REVISED
TANC COMMENTS
ON THE CAISO'S 2014-2015 DRAFT TRANSMISSION PLAN

Figure 1
2016 - CDWR Generation Limited to 500 MW for Hydro Study Points Less than 100%

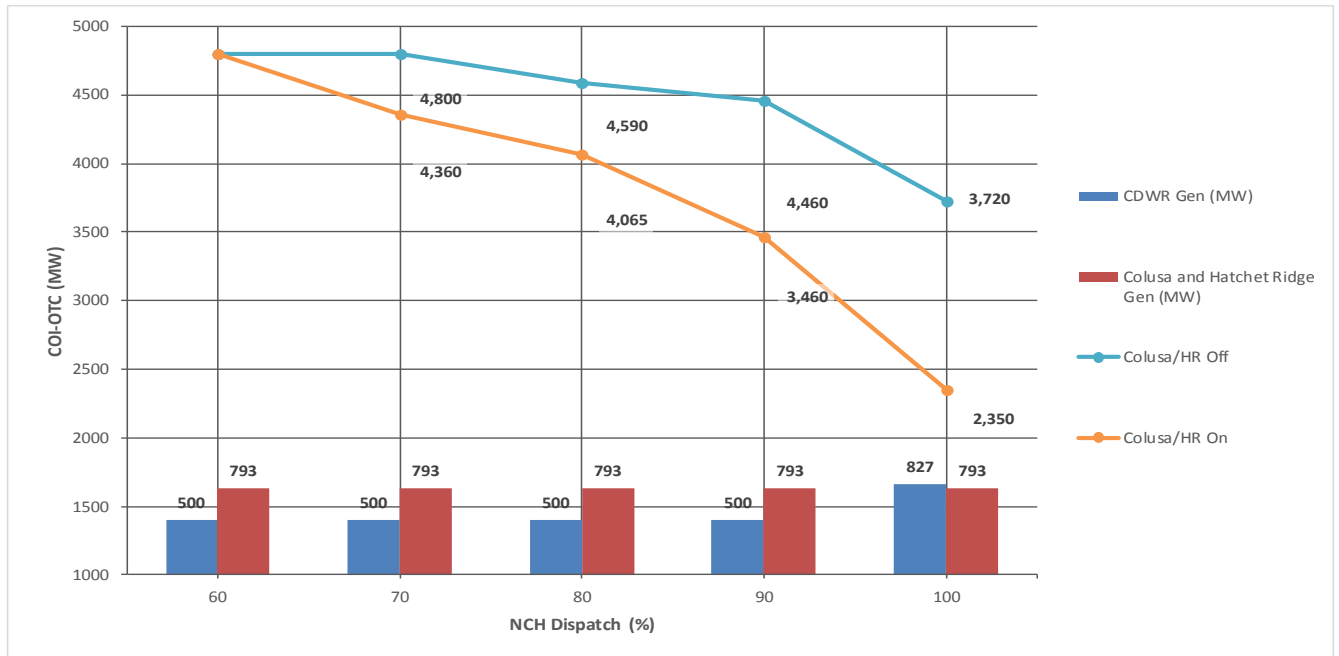
With respect to the information presented in Figure 1:

- The COI flows without the Colusa and Hatchet Ridge projects on line were limited as shown to mitigate flows on the Round Mountain-Cottonwood #3 230-kV line or the Eight Mile Lodi 230-kV line. It is noted that the COI limits in the above nomogram are lower than those in the 2014 summer operating nomogram (which included use of the CDWR RAS) as follows:
 - 110 MW at the 80% hydro level
 - 240 MW at the 90% hydro level
 - 955 MW at the 100% hydro level

- The COI flows with the Colusa and Hatchet Ridge projects on line were limited as shown to mitigate flows on the Delevan-Cortina 230-kV line. As shown in Figure 1 the COI limits with these two projects on-line are lower than the limits with the two projects off-line as follows:
 - 440 MW at the 70% level
 - 525 MW at the 80% level
 - 1,000 MW at the 90% level
 - 1,370 MW at the 100% level
